**West Culburra Mixed Use Concept Plan
Major Project 09-0088, Now SSD 3846
Supplementary
Response to Submissions**

John Toon Pty Limited
July 2017

1. Introduction

Figure 15. Provisional Plan for Stage 1.

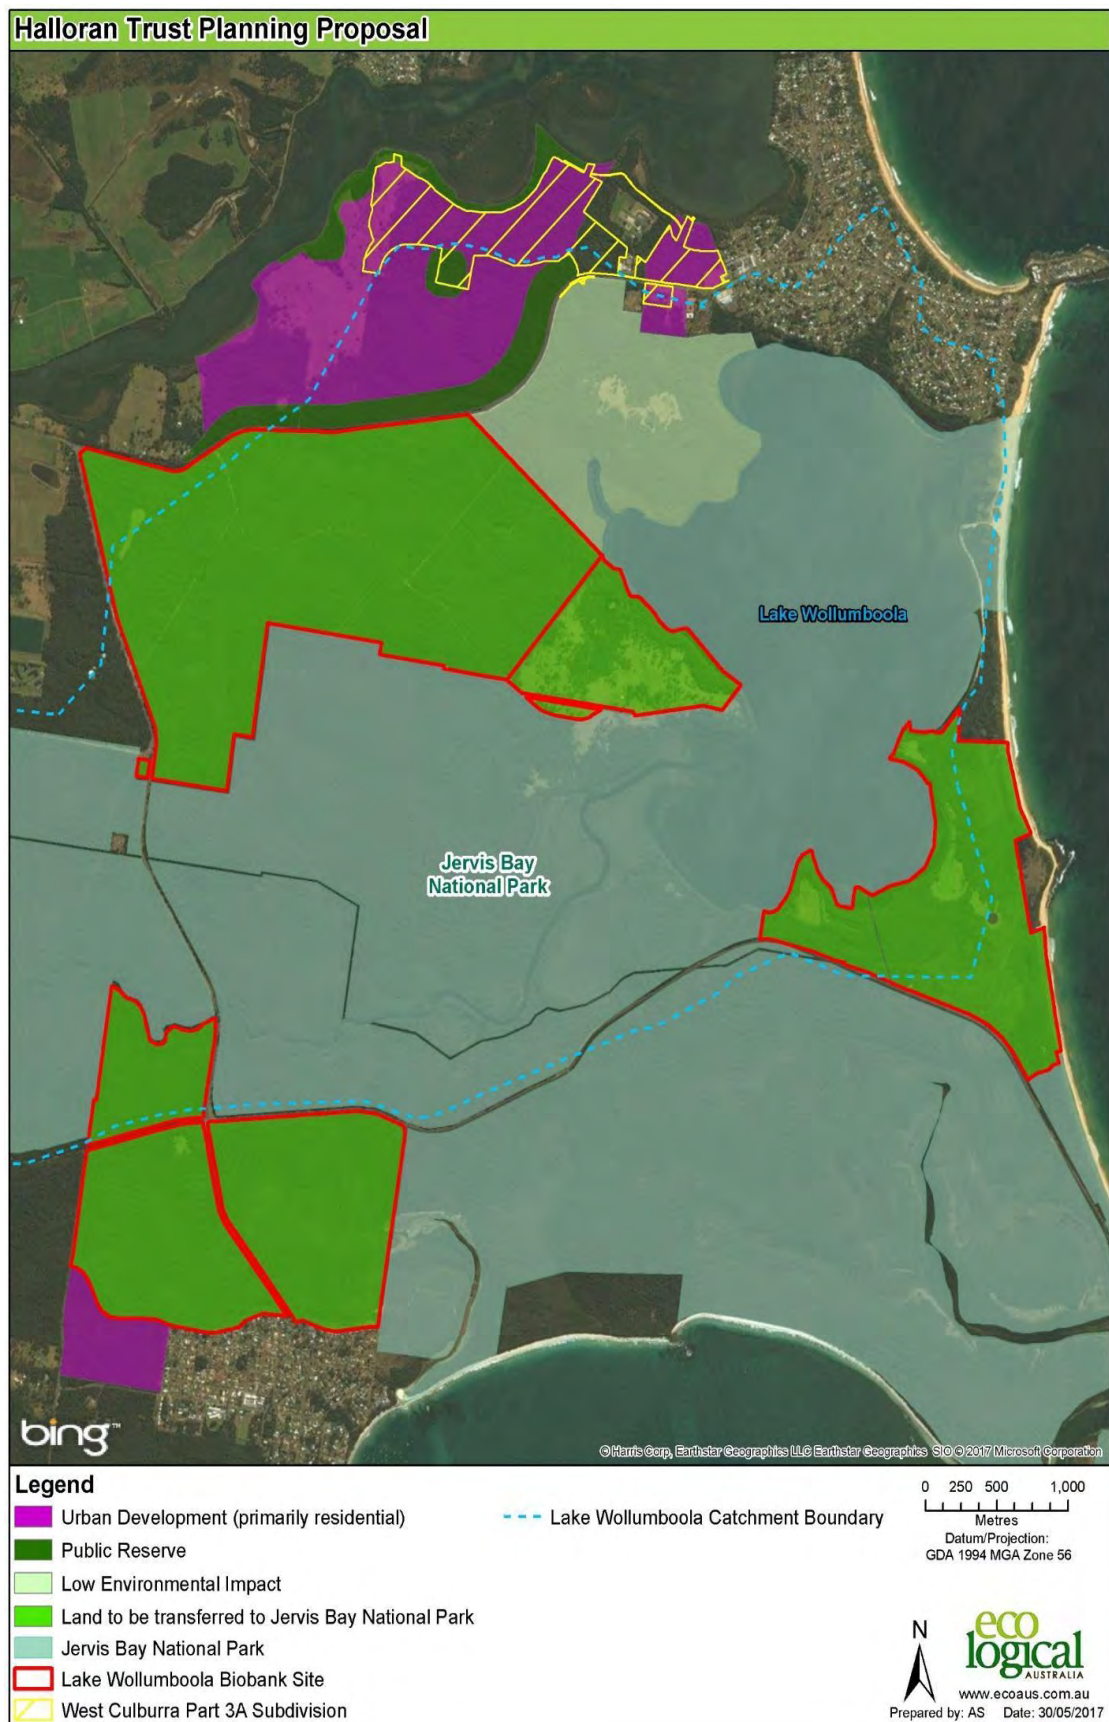
1.4 Removal of uses: Stage 1 in 5(a) zone.	Residential uses removed from 5(a) zone; roads (a permitted use) retained for access.	See Concept Plan and Figure 15 for preliminary layout of Stage 1.

2.5 The southern part of Stage 1.	Southern part of Stage 1 retained. Detailed site survey enabled area that can be drained by gravity to Culburra Road to be proved up.	See Section 9.5, Concept Plan and Figure 15 for preliminary layout of Stage 1.

Principle Issue	Elaboration of Issue	Action Taken	Where Located in RT5
	8.2 APZ for 55+ housing.	The 55+ housing estate has been replaced with a small lot subdivision.	See Figure 15 – Stage 1 Residential development and Concept Plan.

11. Social/economic justification	11.1 Justification of residential mix proposed.	No further action on residential mix.	See Sections 2 and 3; and Figure 15 for indicative mix of lot sizes.
